RE: Google Downtown West Mixed-Use Plan and DSAP Outreach

**SUMMARY OF COMMENTS AND QUESTIONS REGARDING THE DIRIDON  
STATION AREA PLAN BASED UPON THE "DSAP PRELIMINARY CONCEPT  
HEIGHTS" MAP**

# DSAP Preliminary Concept Heights

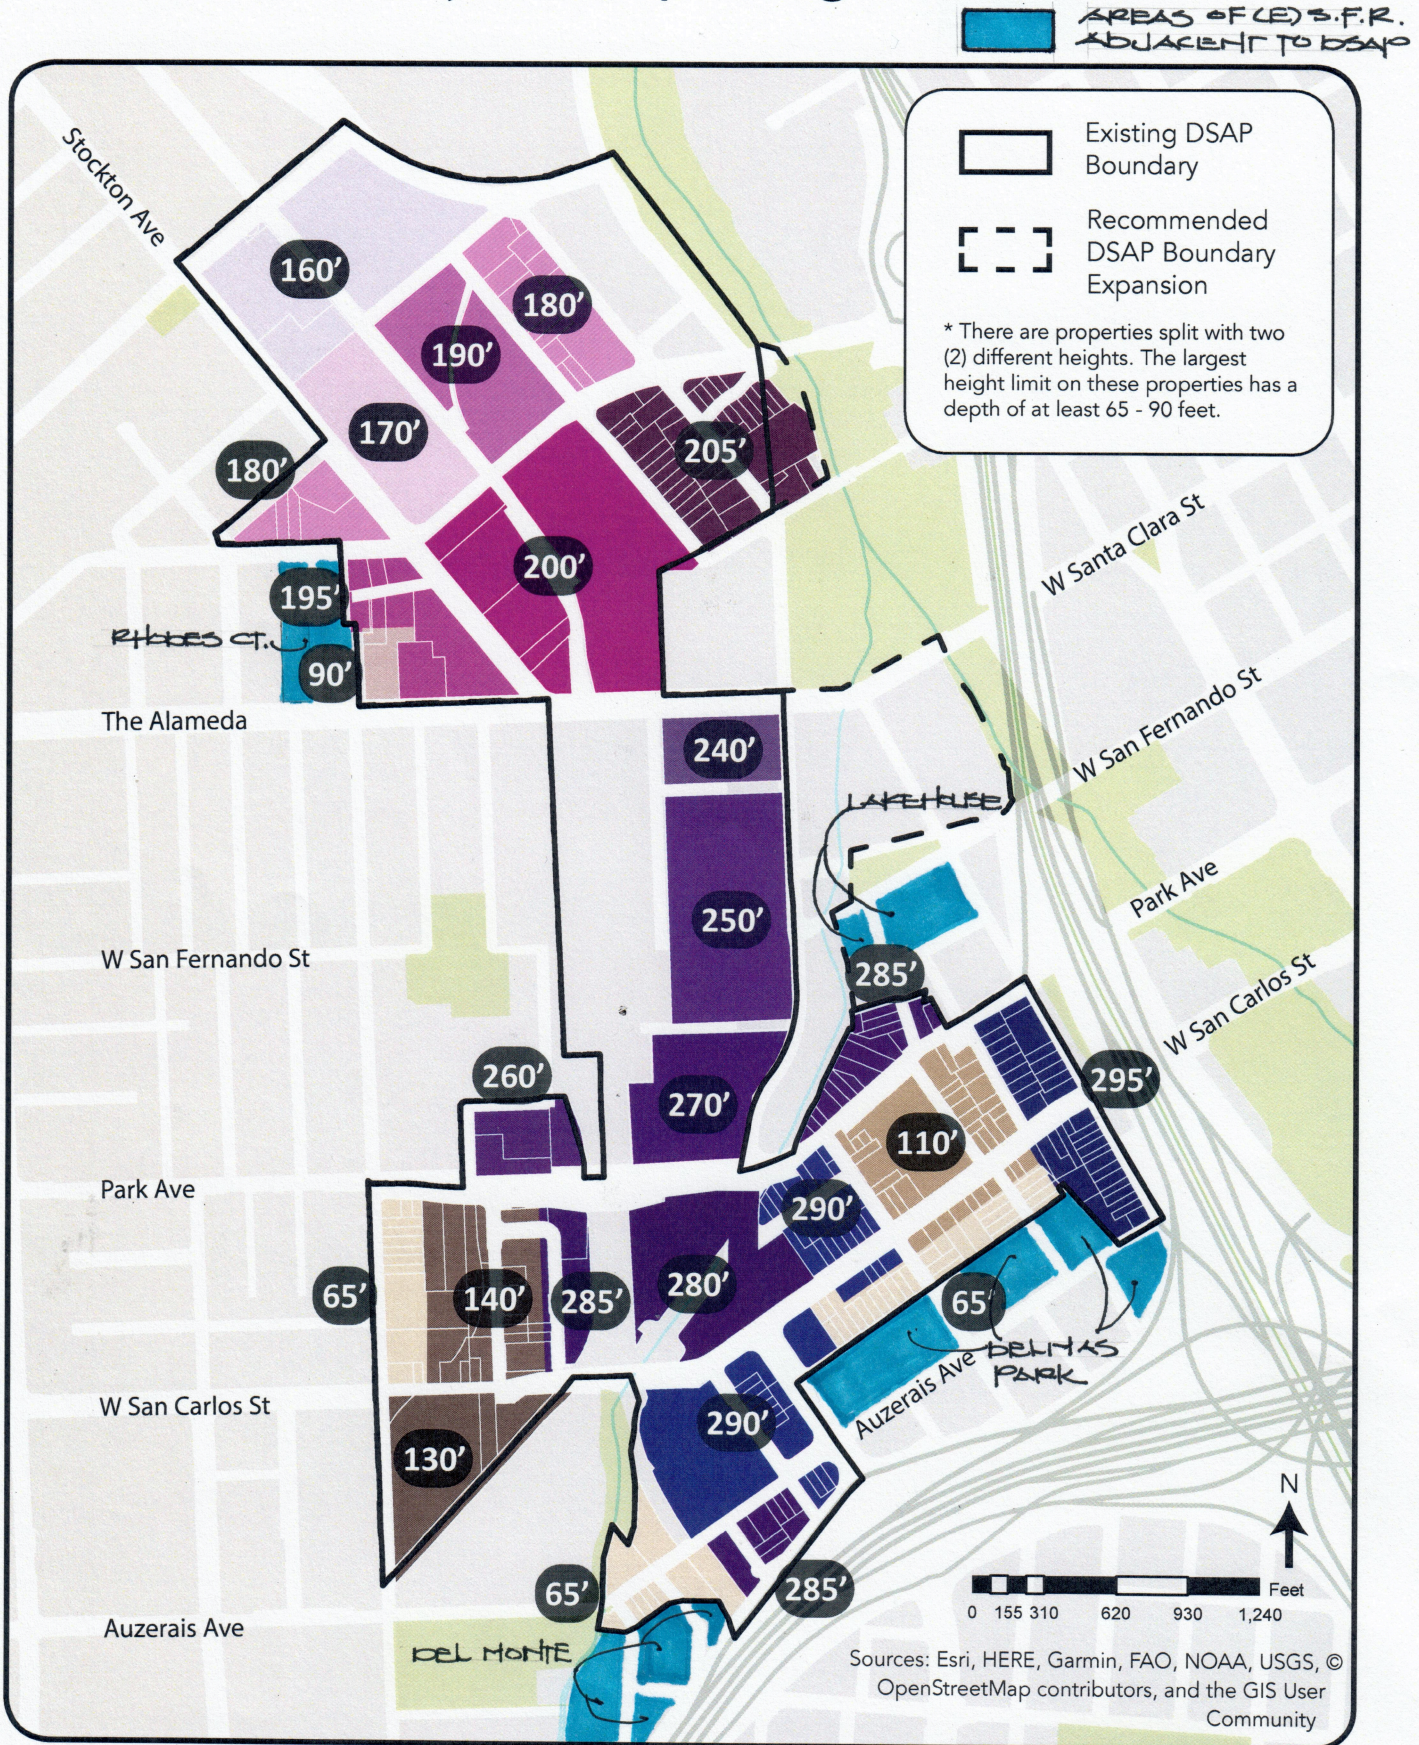
**Staff has identified this map as their current thoughts on development height in the DSAP area under the new FAA limit.**

The DSAP Preliminary Concept Heights Map colors over existing developments and ignores finished or entitled development projects. This map must be updated to provide a realistic view of building height developments with special attention paid to how infill development will interface with existing neighborhood developments and the Los Gatos Creek.

**Update the map to show all entitled, under construction/occupied site within and adjacent to the DSAP area with existing or proposed building height.**

**Update the map to provide development heights for locations adjacent to the Los Gatos Creek to ensure proper top of bank, shade and reflection setbacks.**

**Include the current building heights for properties that are just outside of the DSAP boundary to give a sense of how the proposed height will interface with adjacent buildings.**
